**To:** Colin Kinton, PE – Beaufort County, SC  
**From:** Mark Lenters – Ourston, and Joe M. Garcia, PE – Ourston  
**Subject:** Bluffton Parkway at Bluffton Road (SC 46)  
Roundabout In-Service Review  
**Date:** February 15, 2018

**FULL RE-DESIGN DIAGRAM**

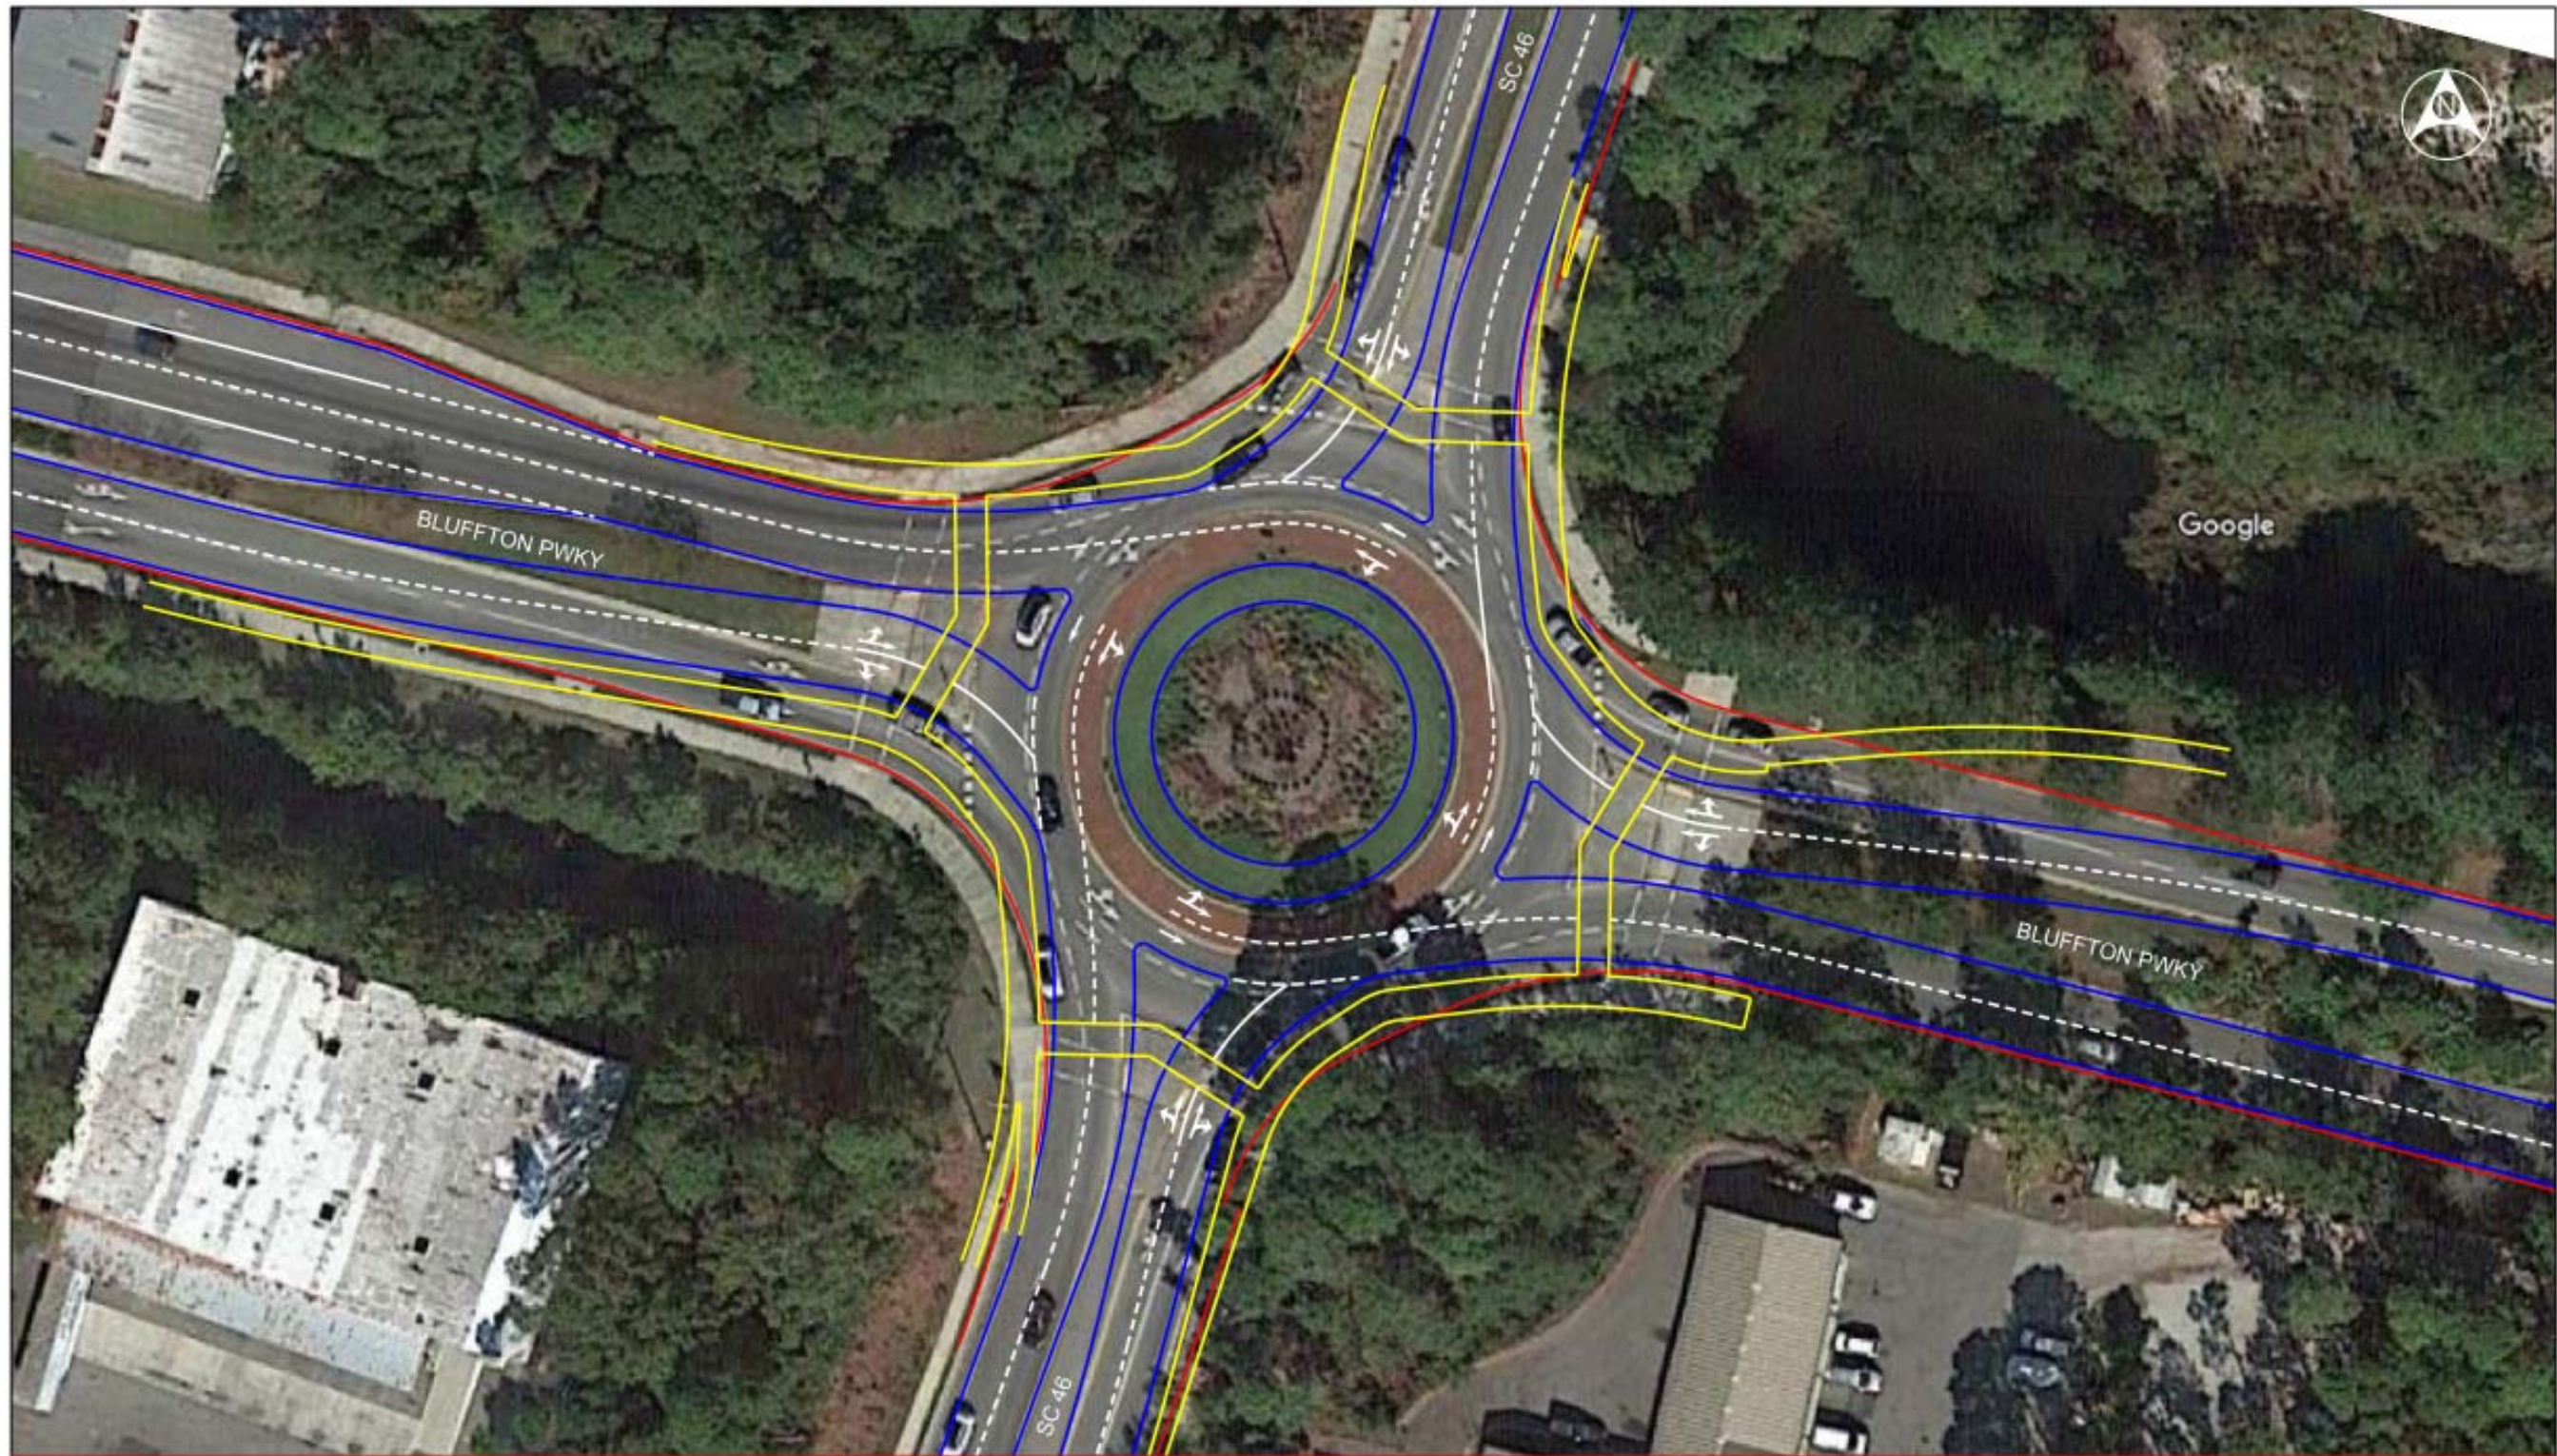
The rebuild alternative is the highest cost option, but provides the ideal geometric design based on current design standards. The redesigned roundabout is able to fit within the existing curb lines and would not require ROW acquisition for its rebuild, see Exhibit 8.0. The roundabout conforms to present day design practices including an offset-left design, 160' ICD, longer path tangents on entry and exit, entry speeds of 28 MPH or less, and reducing vehicle conflict areas. A comparison of the current and full rebuild roundabout design conflict areas are shown in Exhibit 9.0. As seen in this exhibit, conflict areas and conflict path lengths are reduced, especially the outside lane. Vehicles also travel on a tangent through the conflict area rather than curves currently experience in the existing design. By reducing this conflict area, reduced entry speeds, and longer entry and exit path tangents failure to yield and improper lane change crashes are expected to decrease to within national averages. Further driver education is still strongly encouraged with this countermeasure.

FULL RE-DESIGN WITH BYPASSES DIAGRAM

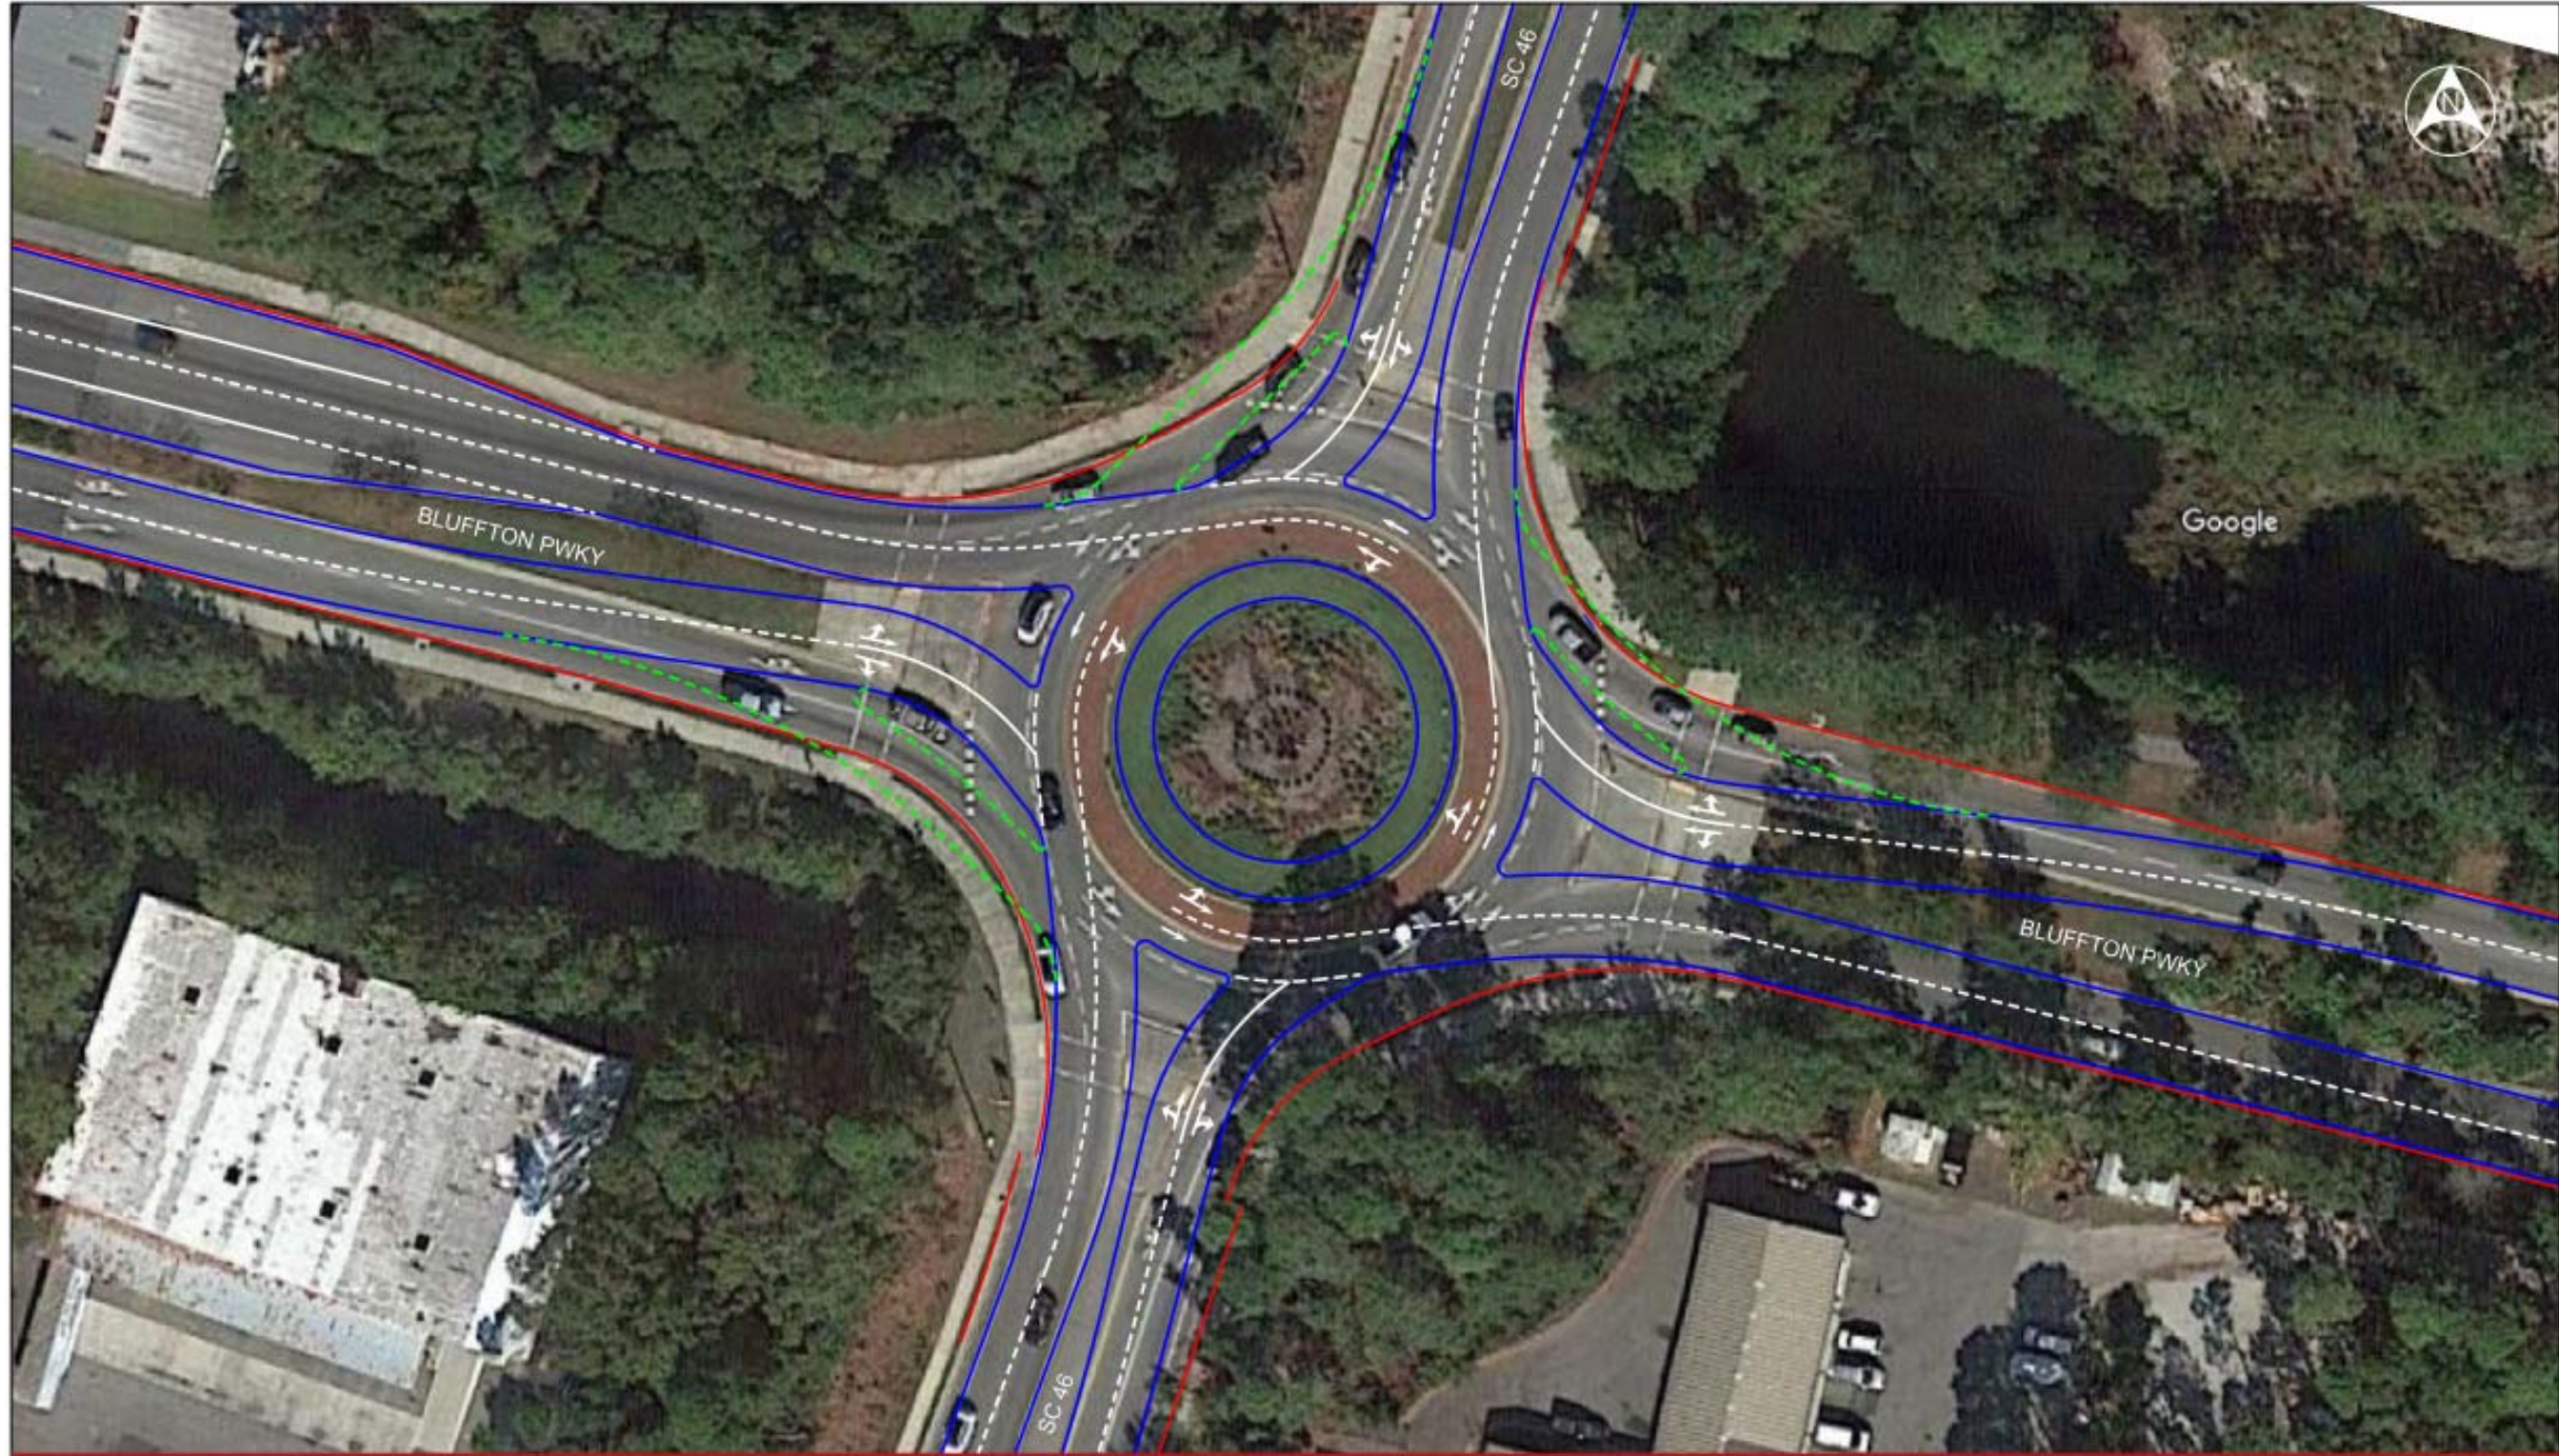
Additional residual capacity can be achieved by adding right-turn yielding bypasses to the eastbound, westbound, and southbound approaches. By adding bypasses to these approaches an additional 8% residual capacity is gained, resulting in a critical residual capacity of 24% in the AM Peak. At a compounding growth rate of 2% per year the roundabout is expected to operate well for 11 to 13 years, but will begin to experience peak hour delays after 11 years. Detail reports of this analysis are seen in Appendix A. The bypass lanes can be constructed when they are necessary or installed concurrently with the overall reconstruction . A concept layout of the full rebuild with the additional right-turn yielding bypasses are show in Exhibit 9.0.
